PCN-20190311 TE0725LP-01 Flash Change

Company	Trenz Electronic GmbH
PCN Number	PCN-20190311
Title	TE0725LP-01 SPI Flash Change
Subject	BOM change
Issue Date	20190311

This change affects all TE0725LP modules of revision 01: TE0725LP-01

Locate Flash (U7) on backside of PCB:

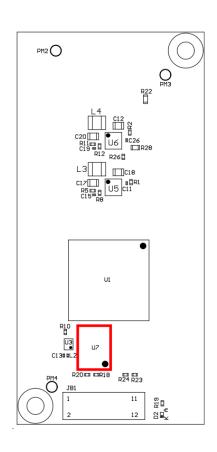
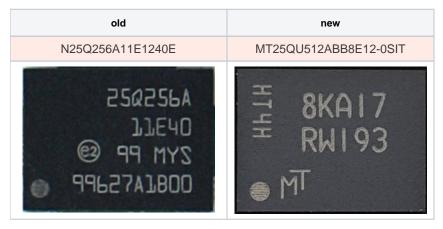
#1 Change SPI Flash from N25Q256A11E1240E to MT25QU512ABB8E12-0SIT

Reason: N25Q256A11E1240E became obsolete.

Impact: Size changed from 256 MBit to 512 MBit. JEDEC ID changed from BB19h to BB20h both with manufacturer ID: 20h.
